PLAN AND ZONING COMMISSION MEETING

Case F21-10: Request of Catherine Cartee for a Final Plat of a 2 lot subdivision on 2 acres located at 4837 West Locust Street. [Ward 1]

FINAL PLAT OF
CARTEE'S 5TH ADDITION
BEING REPLAT LOT 2 OF CARTEE'S 3RD ADDITION
(DOC #2006-5958), BEING PART OF THE NORTHWEST
QUARTER OF SECTION 29, TOWNSHIP 78 NORTH,
RANGE 3 EAST OF THE 5TH P.M., CITY OF DAVENPORT,
SCOTT COUNTY, IOWA

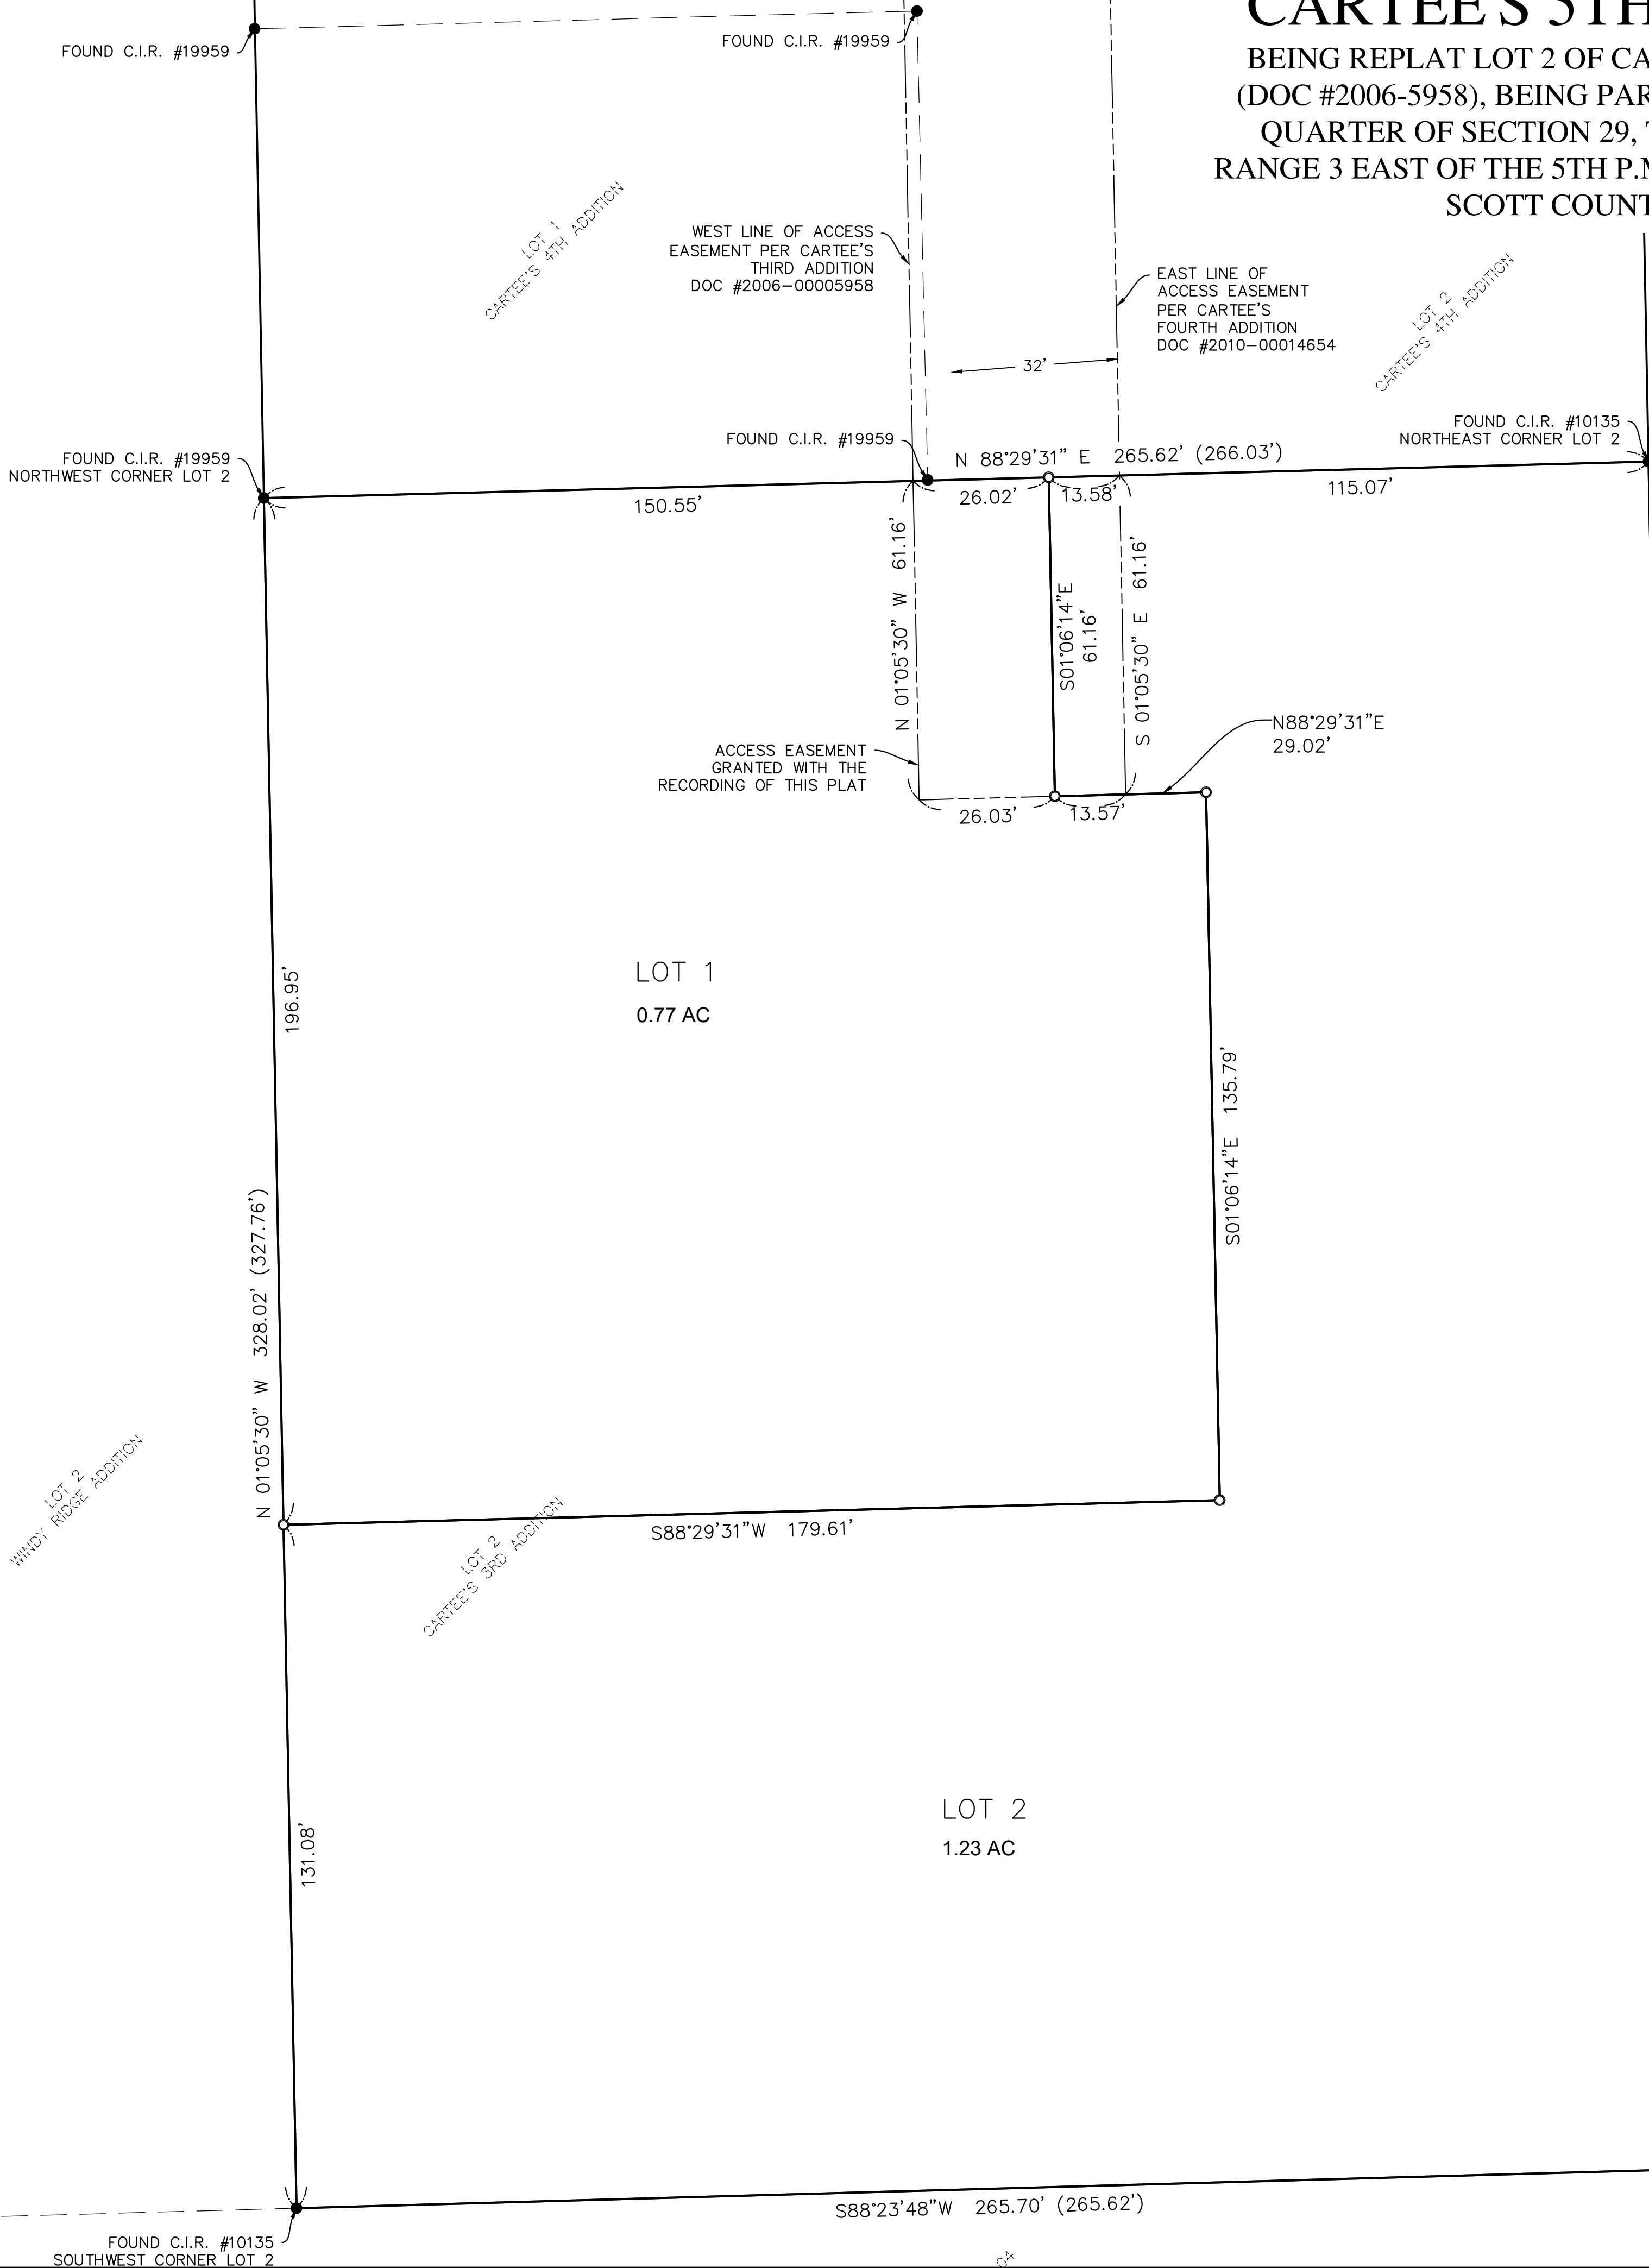
1. That the surveyor signs the plat.
2. That the utility providers sign the plat when their easement needs have been met.
3. Submit an updated access easement and maintenance agreement providing all existing and proposed lots with access rights.
4. Show all existing utility easements.
5. Add a note stating, "Blanket underground easements granted for all primary and secondary electric cables, pad mounted transformers, electric transformers, primary cables, gas service, gas main, utility poles, manholes, water service, sewer lateral, telephone service and cable T.V. service to individual structures and street lights.

- Streets: The proposed plat is located south of West Locust Street, an arterial street. Access to the lots would be by way of an existing driveway. An access easement is required.
- Storm Water: Stormwater regulations will apply in a development with more than 5,000 square feet of impervious surface. This includes houses and driveways.
- Sanitary Sewer: Sanitary sewer service is located to the southwest and is accessible for this development.
- Other Utilities: This is an urban area and normal utility services are available.
- Parks/Open Space: The proposed plat does not impact any existing or planned parks or public open space.
